NAVIGATION – STANDBY COMPASS – WARNING PLACARD (MOD N717A)

ANMD-34-5

Figure 1 Placard Mounting Plate Pattern

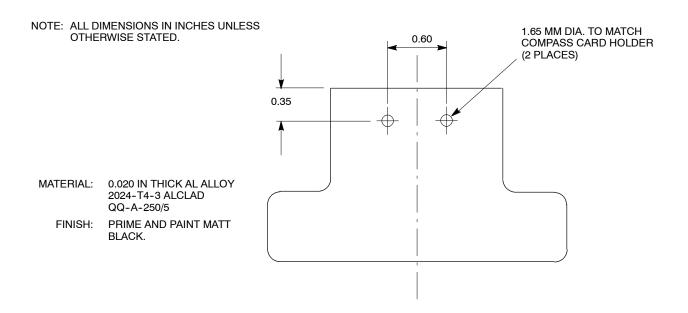
(2) If a placard mounting plate is not existing, remove the compass correction card and card holder from the mounting bracket and manufacture a placard mounting plate as shown in Figure 1. Position the placard mounting plate between the compass card holder and the mounting bracket and rivet in position using two MS20426AD2-4 rivets (Ref Figure 2). Apply the placard to the placard mounting plate and refit the compass card.
